SERVICE BULLETIN

FADEC WIRE HARNESS STAND-OFF INSTALLATION INSPECTION AND MODIFICATION

All MD Helicopters, Inc. (MDHI) MD600 helicopters, serial number RN003 thru RN040.

Electrical Wiring Harness Installation (P/N 600N4262)

Figure 1. FADEC Wire Harness Routing Rework.

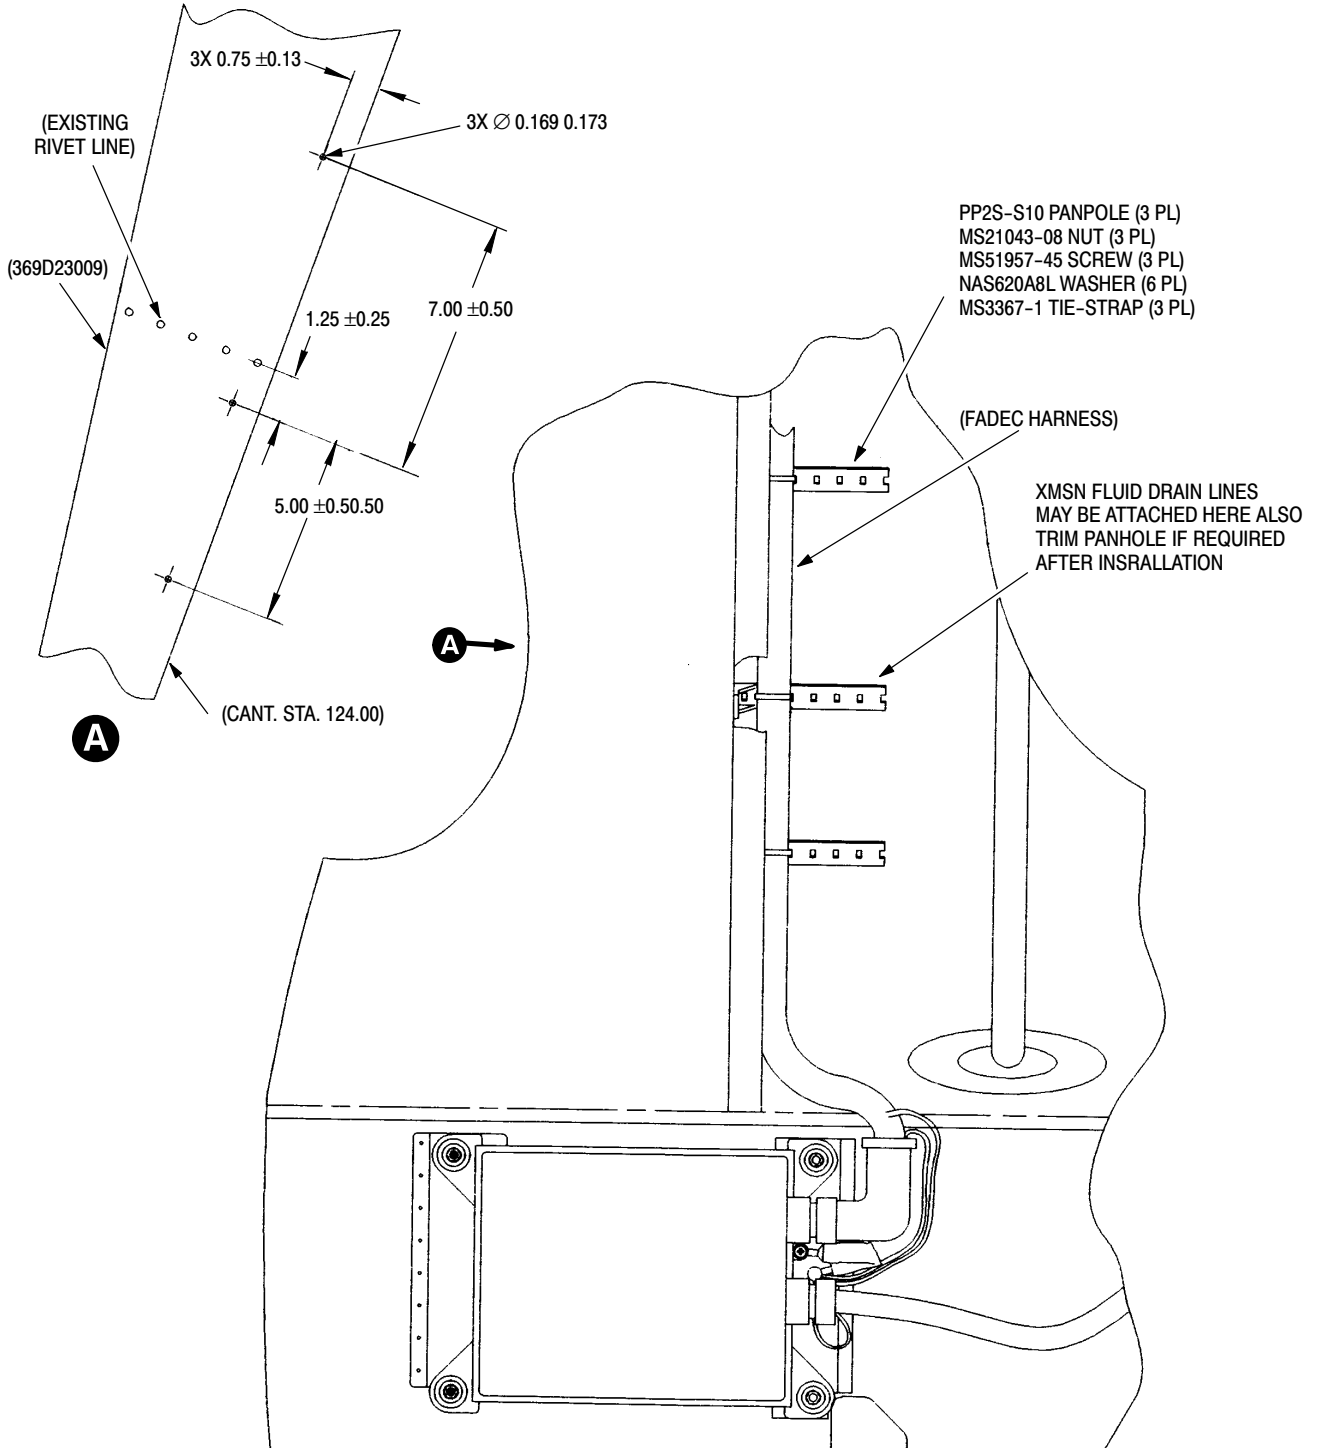
MDHS has discovered that a possible internal wire harness shorting condition may occur if a longer length screw is substituted for the proper screw in the aft compartment trim above the FADEC ECU, in the drive shaft closeout area. Failure to comply with the requirements of this Bulletin could cause FADEC fault lights to illuminate and/or prevent the ship from starting due to FADEC faults.

Procedures in this Bulletin provide owners and operators with information pertaining to inspecting the FADEC wire harness for any possible damage from adjacent hardware. This Bulletin also requires operators to install three pan poles to provide additional clearance for trim mounting screws in the transmission drive shaft area.

- (3). Locate and install the three Pan Pole standoffs as shown on Figure 1.
- (4). Secure FADEC wire harness to the standoffs using tie straps. **NOTE:** The transmission drain lines may be secured to these standoffs as well for convenience. It is not necessary to remove the existing tie bases in the rework area.
